UPDATE REPORT

BY THE DIRECTOR OF ENVIRONMENT AND NEIGHBOURHOOD SERVICES
READING BOROUGH COUNCIL
PLANNING APPLICATIONS COMMITTEE: 30 May 2018

App No: 180144/FUL

Address: 25 Redlands Road, Reading

OS from 1873

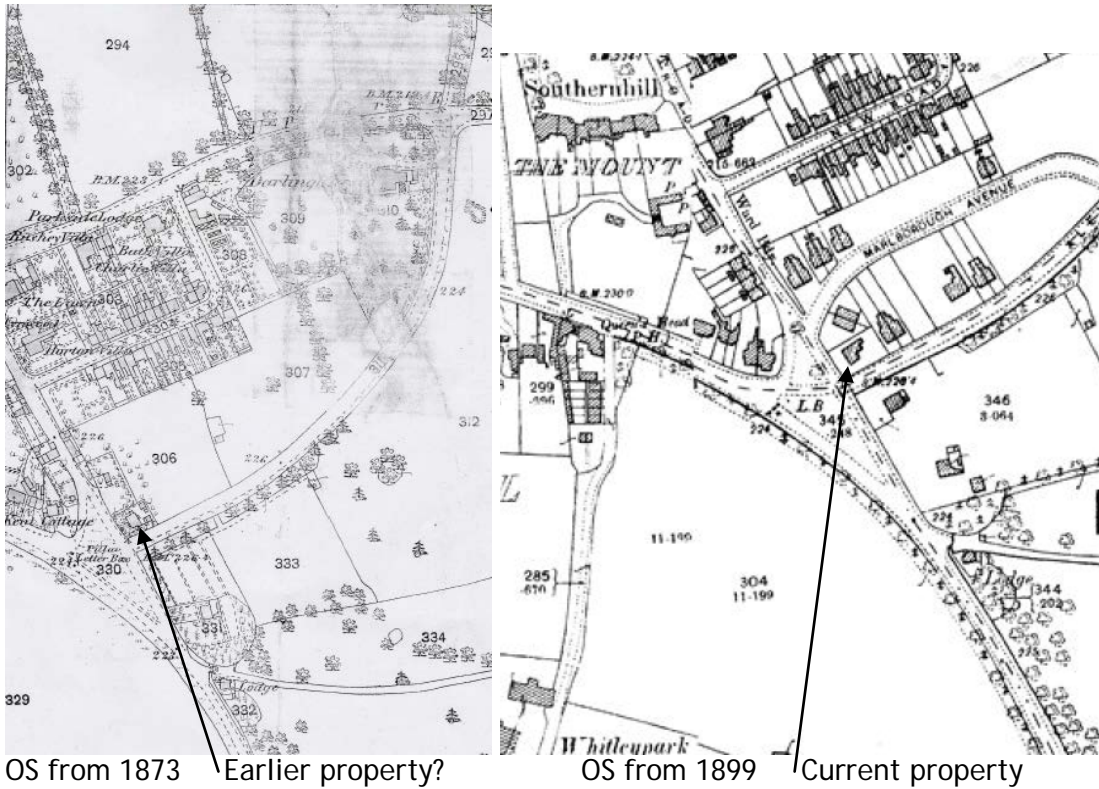
1.3 A neighbour has challenged the age of the existing property as described in the heritage statement by providing a map from 1873 (see below). The applicant has reviewed this and other available maps in detail (one from 1899 shown below) and has responded:

"we have studied this map extract closely and confirm that there is an illustrated record of a building and ancillary out-buildings on the application site in the 1873 OS map. However, the building footprint illustrated is significantly different from that depicted on subsequent maps and which exists on site which suggests that it pre-dates the building currently occupying the site and may have been demolished to make way for the existing building".

- 1.4 Officers consider that, while of interest, the age of the property does not form a significant material consideration in this case as the existing building is being retained.
